#### **Addendum 15 — Regulation No. 16**

#### **Revision 8 — Amendment 3**

Supplement 8 to the 06 series of amendments — Date of entry into force: 22 June 2017

#### **Uniform provisions concerning the approval of:**

Figure 2

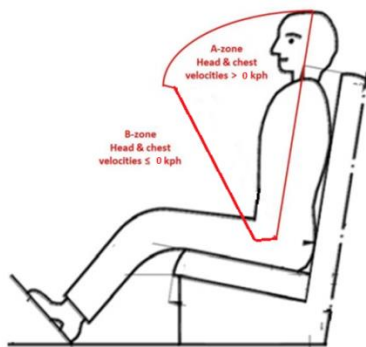
Annex 1B, insert new item 12.1., to read:

"12.1. In case a restraint system has been granted/extended/<sup>2</sup> those can be used for particular types of vehicles compatible with the following dimensional conditions: no interior part in a quoted A-zone as shown below (Figure 2):

"Figure 1  
Specifications of the fixture (all dimensions in mm)

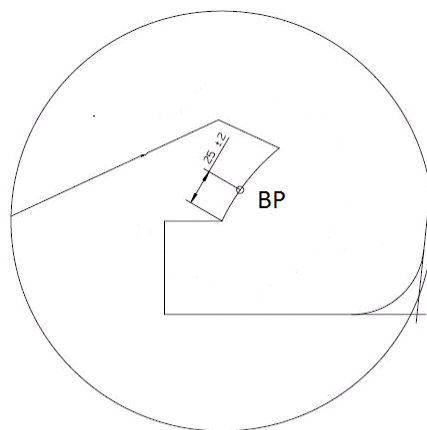
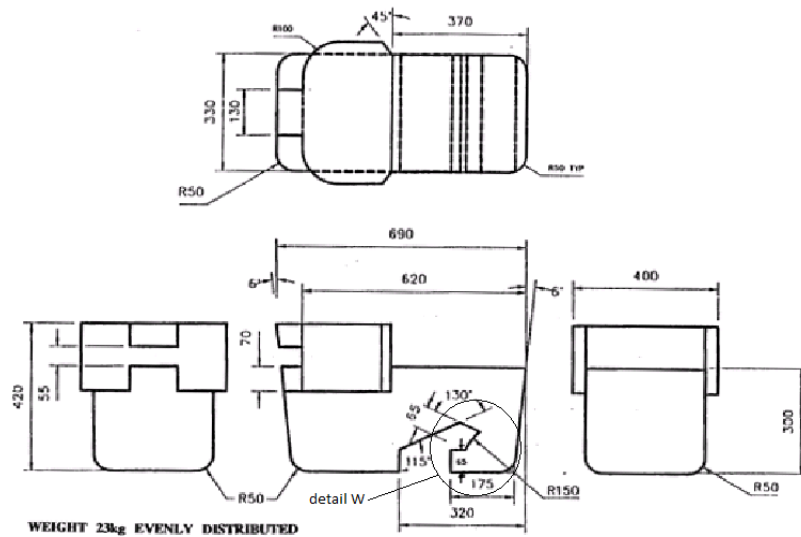
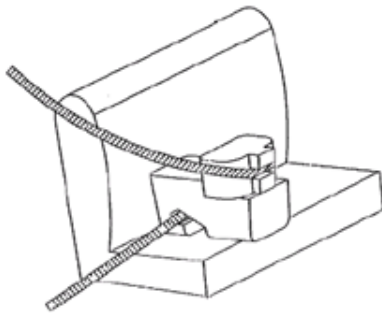
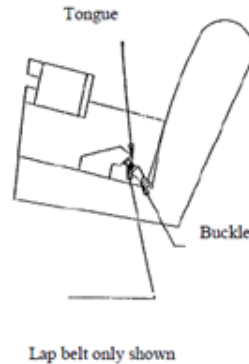
"3.2. The lap portion of the belt shall touch the fixture on both sides at the rear of the lap belt path (see Figure 3). The seat belt webbing shall always cover the points BP on the left and right ends of the curved edge; the exact position of point BP on the curved edge is indicated in detail W of Figure 1."

Figures 1 to 3, amend to read:
